Michigan Department of Environment, Great Lakes, and Energy
Wolverine CAG – Air Monitoring Plan – Construction Phase
October 25, 2023

Figure 1. Proposed Perimeter Air Monitoring Stations (orange dots) with a composite Wind Rose for the Grand Rapids area from 1970-2023 (ISU 2023). The location of the additional Monitoring location is in red.

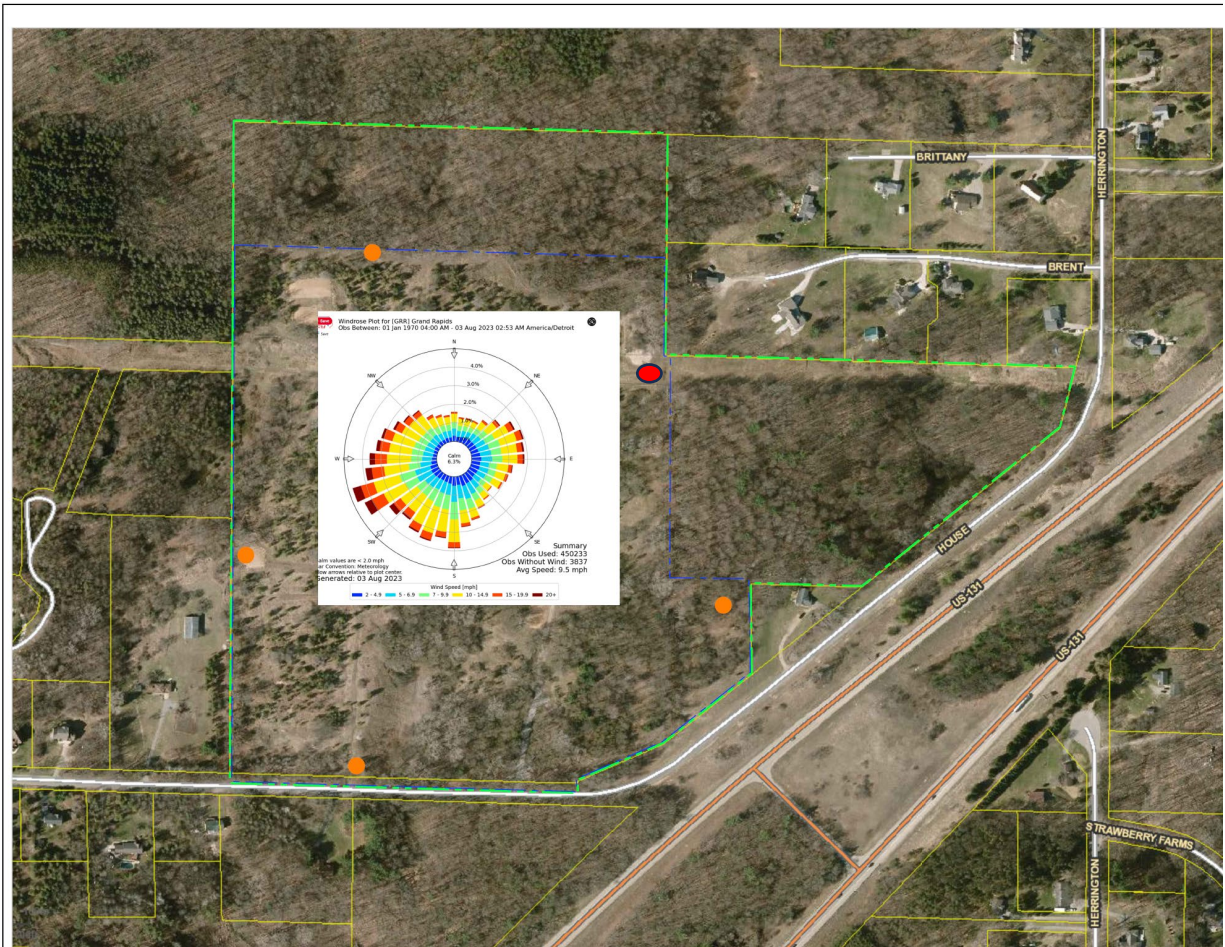
Section 3 states: “The overall project objective is to monitor and minimize risk of exposure of on-site personnel and off-site receptors to target constituents (metals, PFAS, VOCs, and dust) before and during Final Remedy construction activities at the HSP.” WW’s proposed plan is flawed in that it presents no analysis of the prevailing wind direction. The proposed plan relies on four perimeter monitoring stations shown in Figure 1 (orange dots). Wind Roses are graphical charts that characterize the speed and direction of winds at a location. The length of each "spoke" around the circle indicates the time the wind blows from a particular direction. A Composite Wind Rose was added in the center to show the direction of the prevailing wind. Seasonal Wind Roses from the Kent County Airport are included in Figure 2. These figures show that WW’s Air Quality Monitoring Plan provides no coverage for the largest cluster of homes that border the House Street Property (HSP) when the wind is tracking in the prevailing direction and when earthwork is being performed in the center of the site. The Composite and Seasonal Wind Roses show that the prevailing wind direction is out of the Southwest and in the direction of the homes along the Northeast corner. Given the fact any construction in the central part of the HSP could create dust that would be carried by the prevailing wind toward residential receptors, there should be a permanent air monitoring station located in the vicinity of the red circle in Figure 1.

Moving one of the existing stations will limit the proper coverage necessary to protect public health.
